CITY OF FRAMINGHAM, MA DEPARTMENT OF PUBLIC WORKS EDGELL ROAD WATER PUMPING STATION REPLACEMENT CONTRACT NO. PW-428 JANUARY 2020

9/14/2021 1:31 PM U:\7163 - EDGELL WPS CONSTRUCTION SERVICES\CHANGE ORDERS\CONSTRUCTION STAGE CHANGES\UPDATED CITY BYPASS CONNECTION.DWG (BETA STB BW.STB)

TITLE
Edgell Road Water Pumping Station Replacement
Bypass And Restoration Plan

SHEET NO. C-2

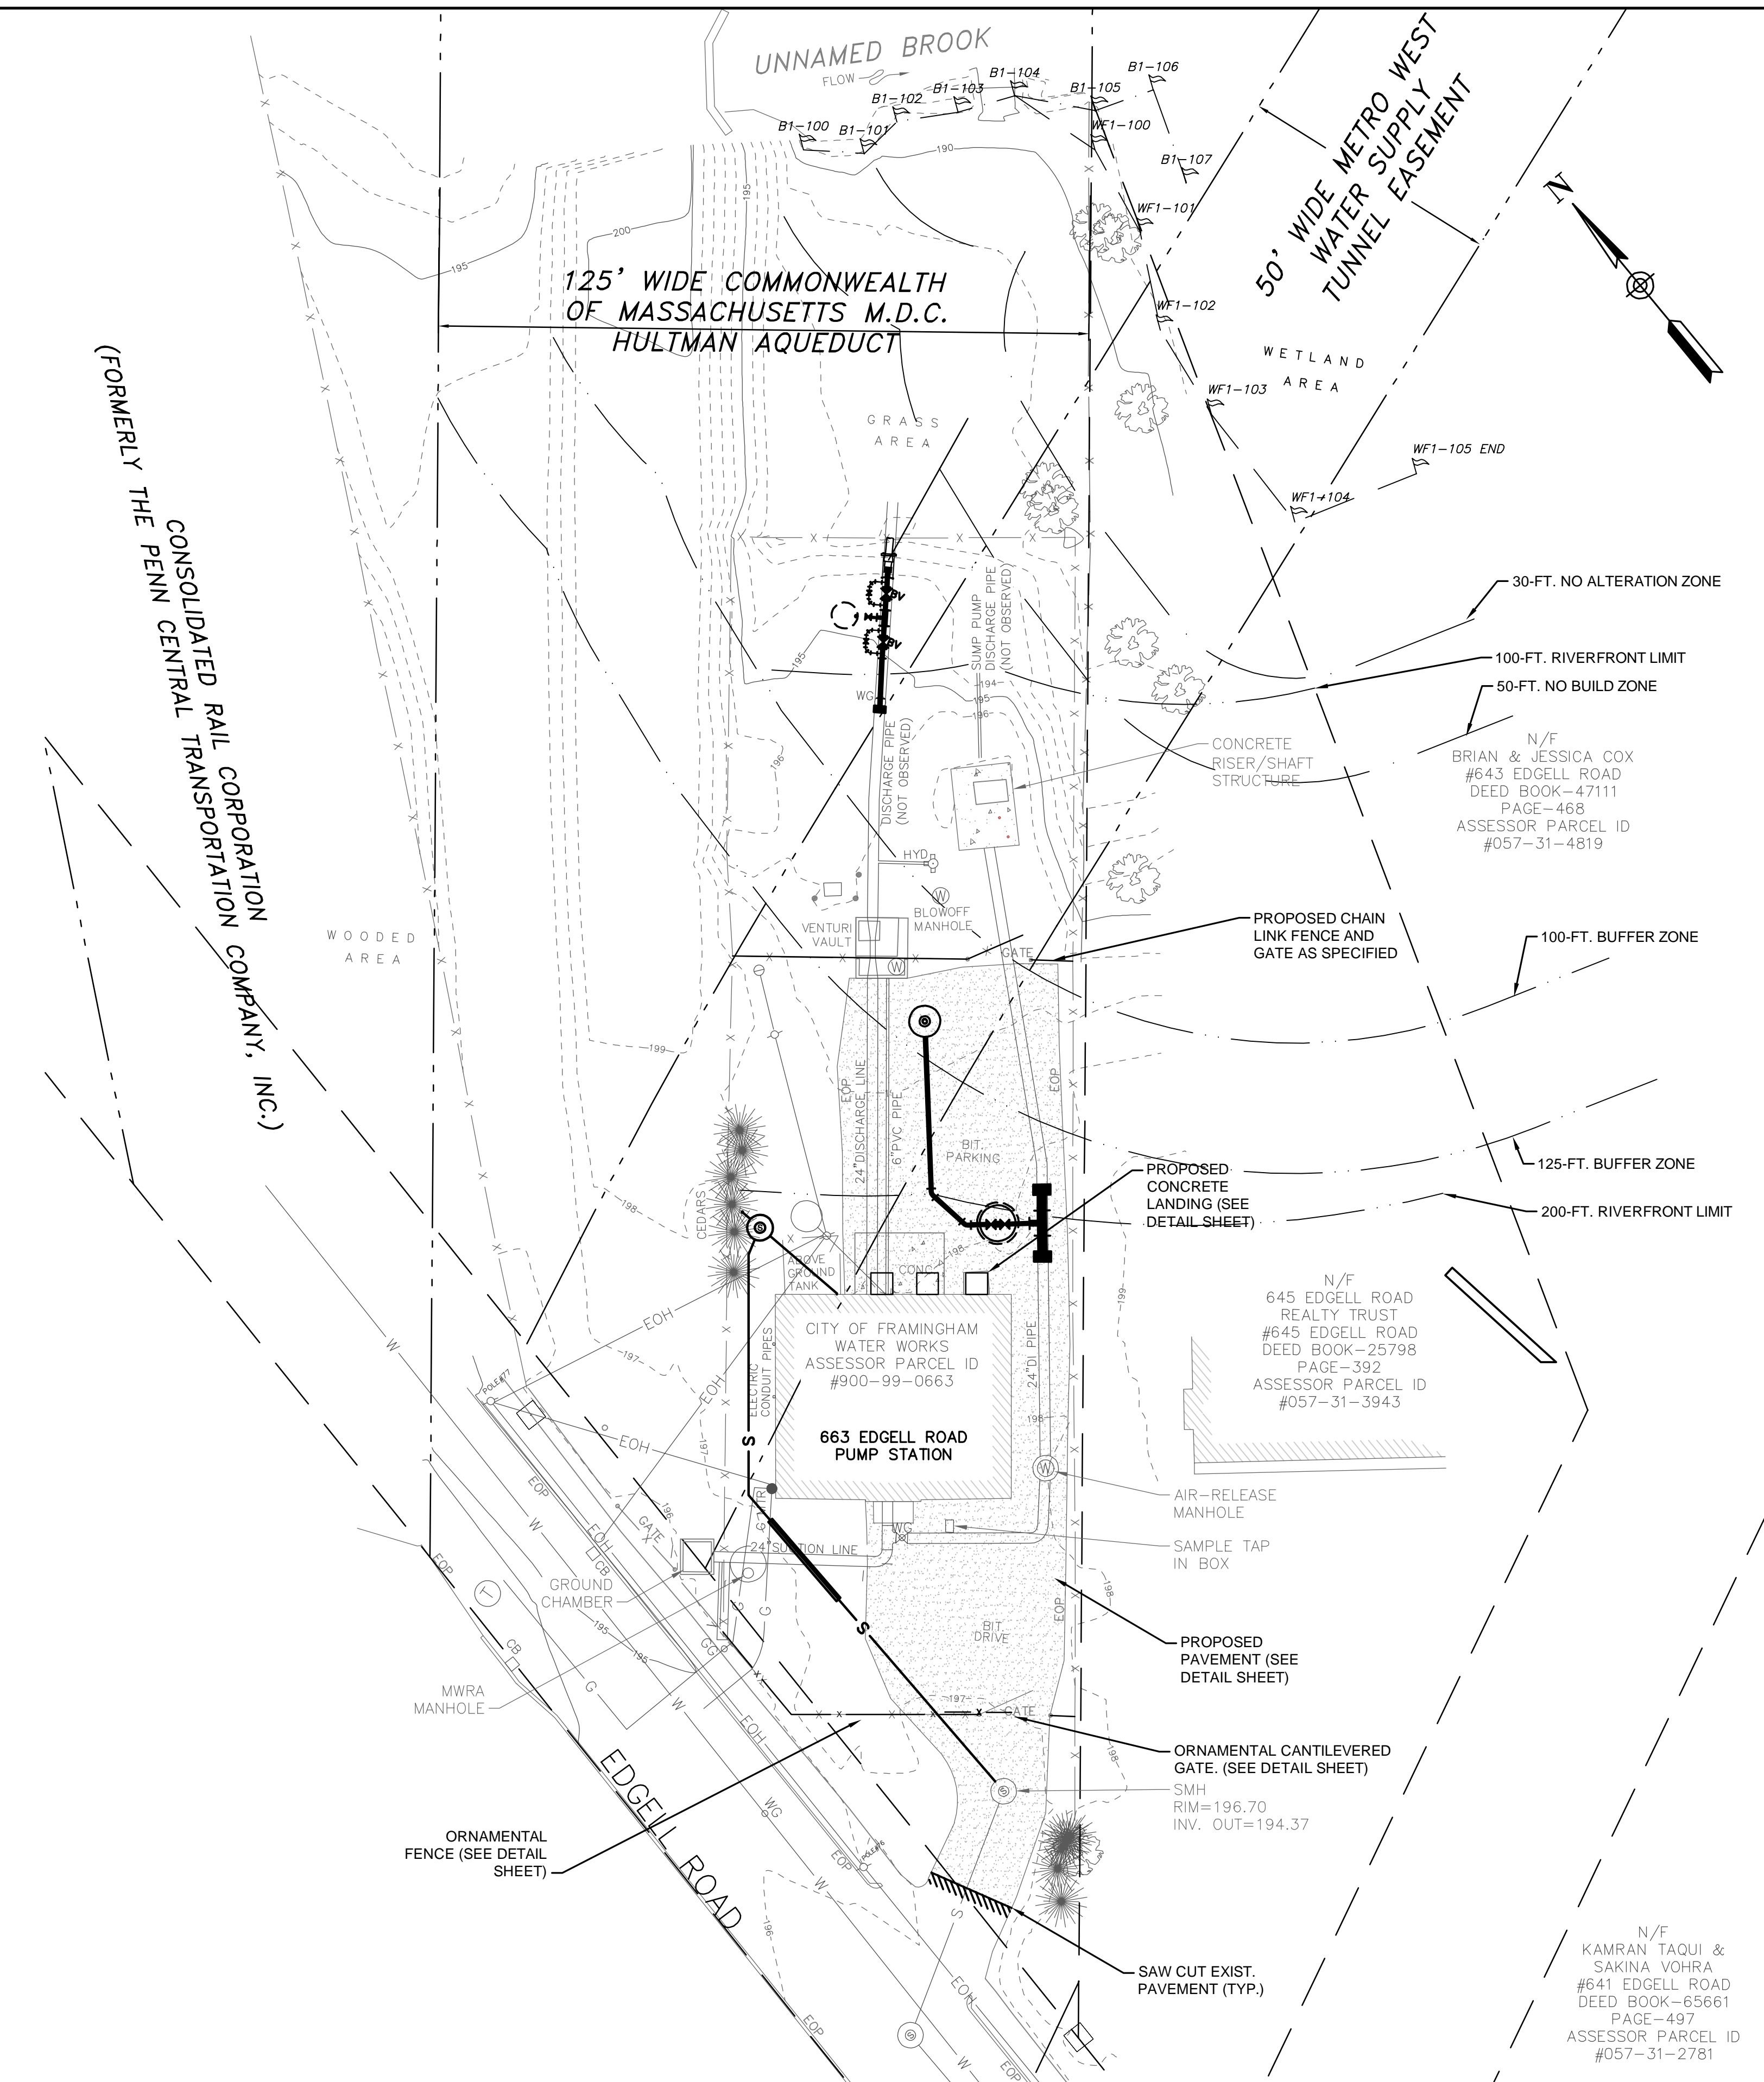
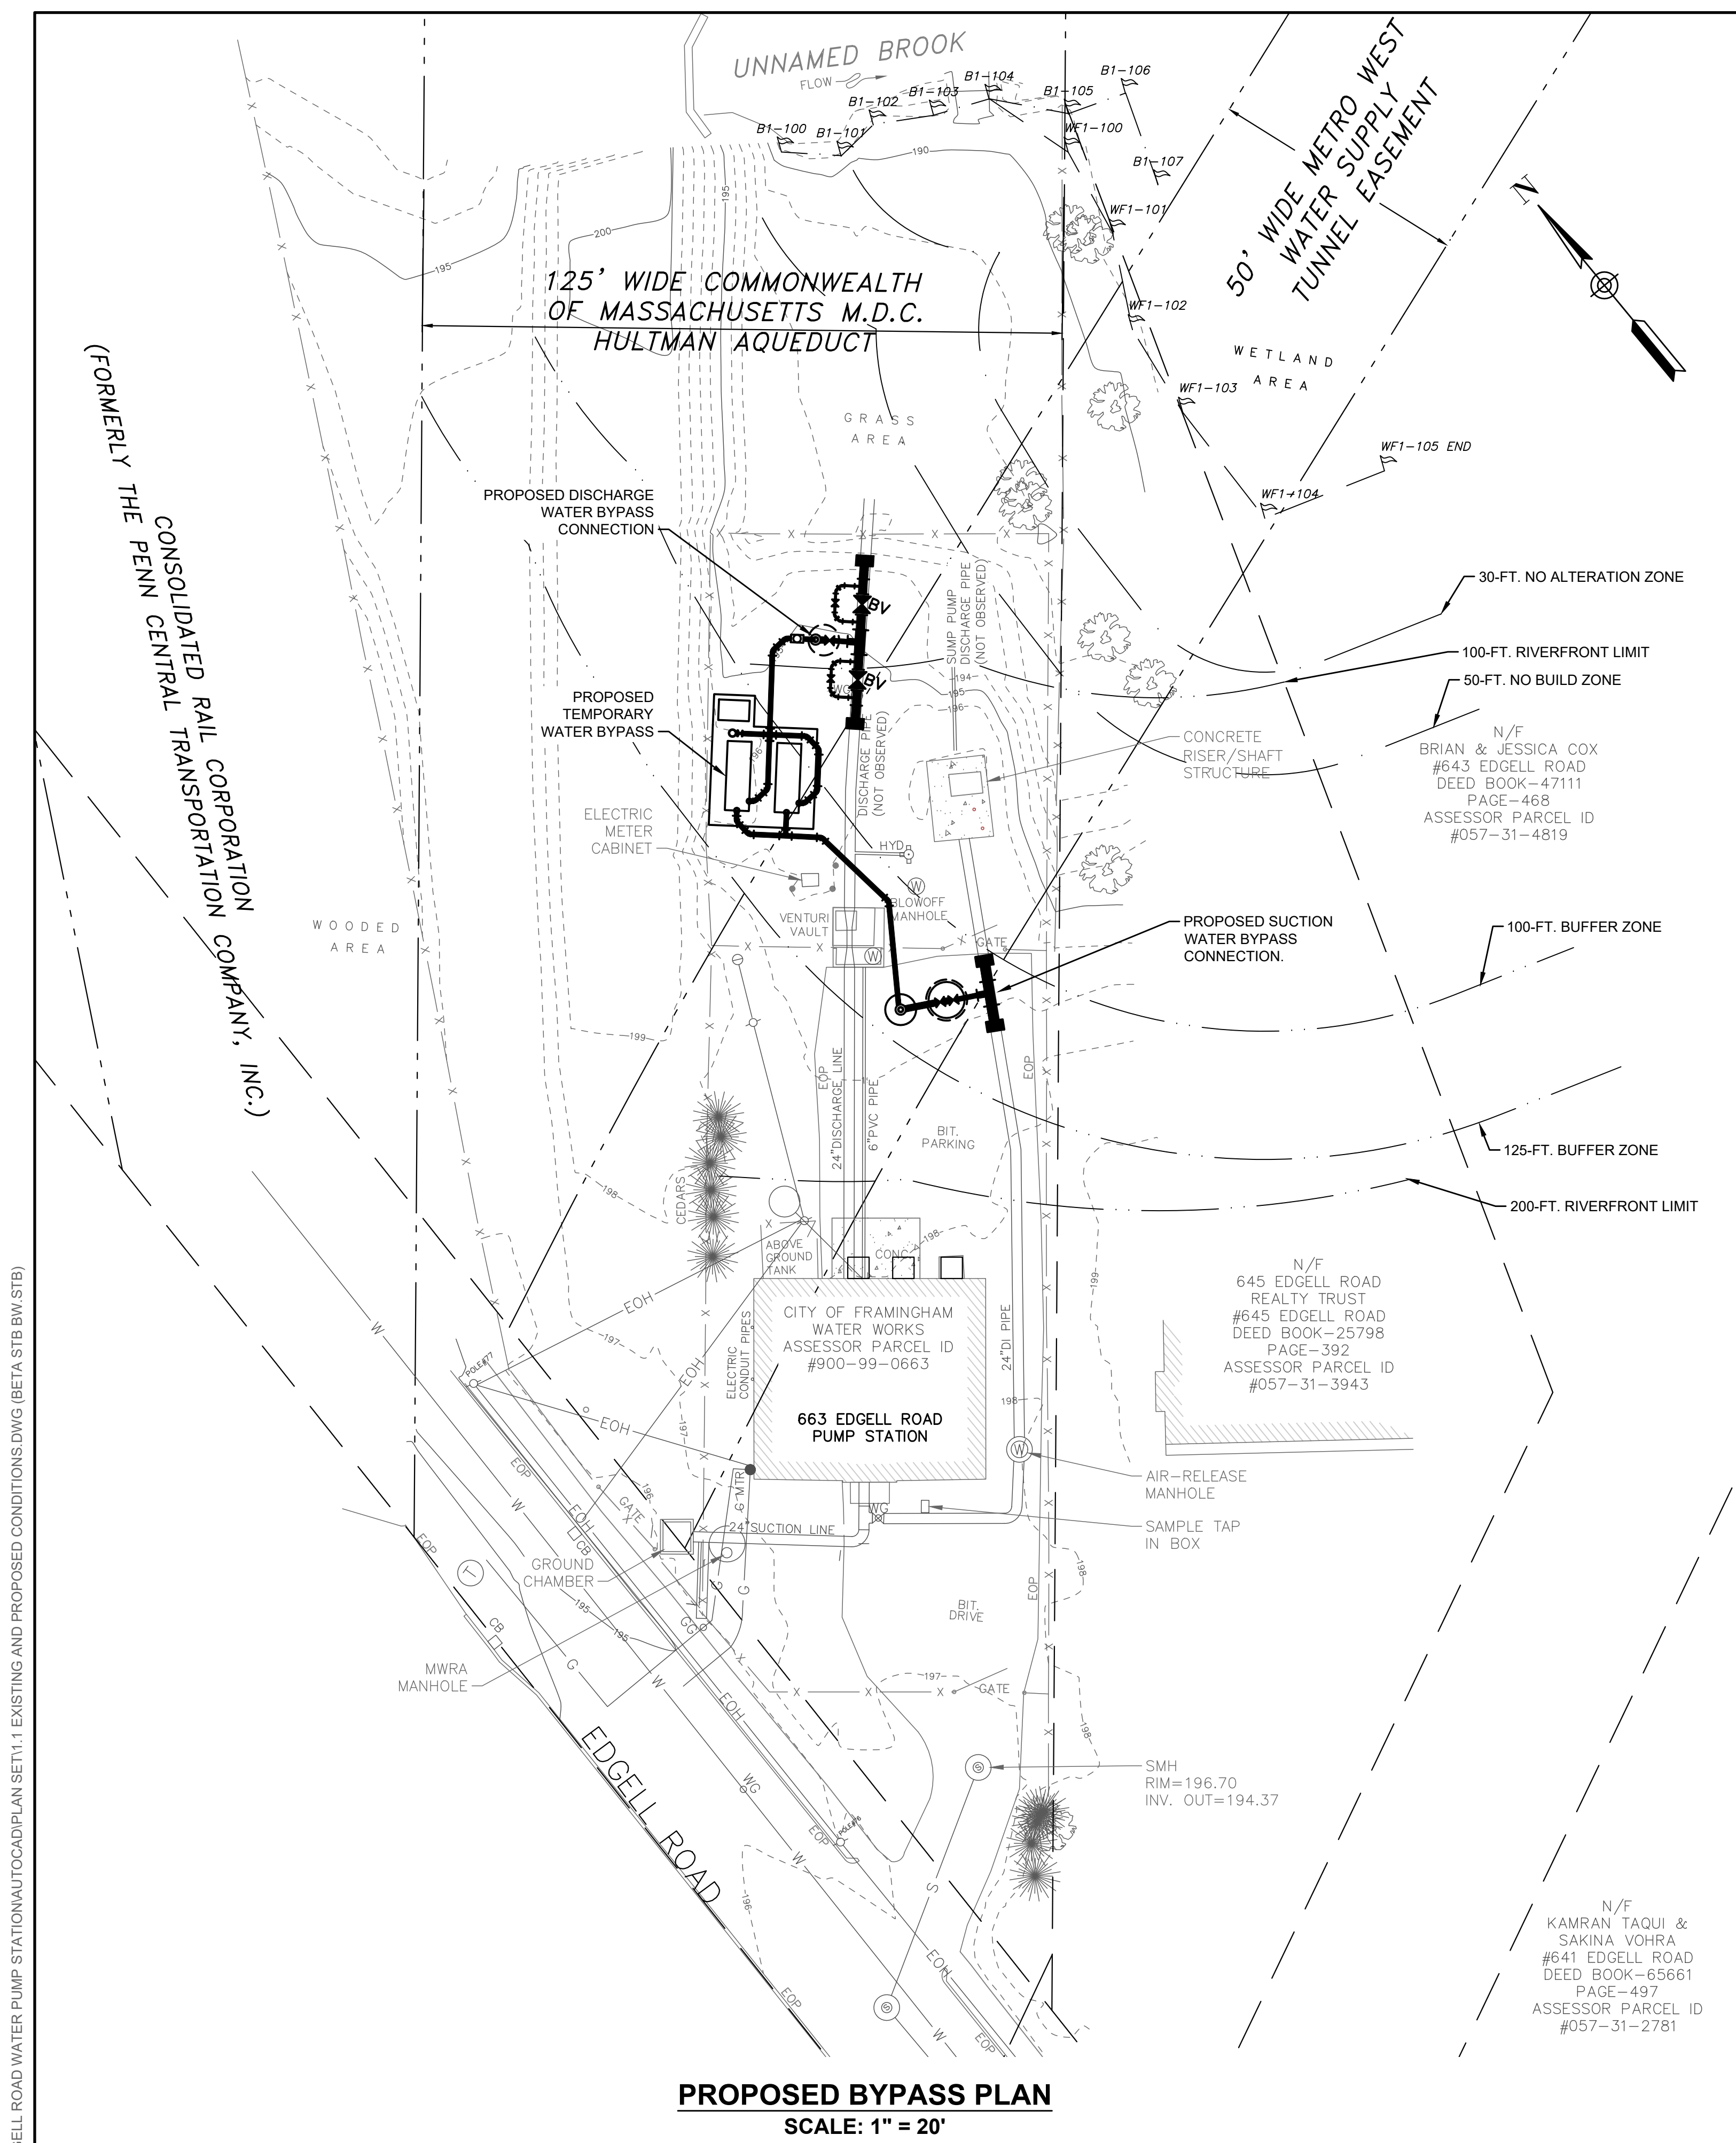
NUMBER	DATE	MADE BY	CHECKED BY	REVISIONS
1	5/14/21	AJG	JRD	UPDATED BYPASS CONNECTIONS
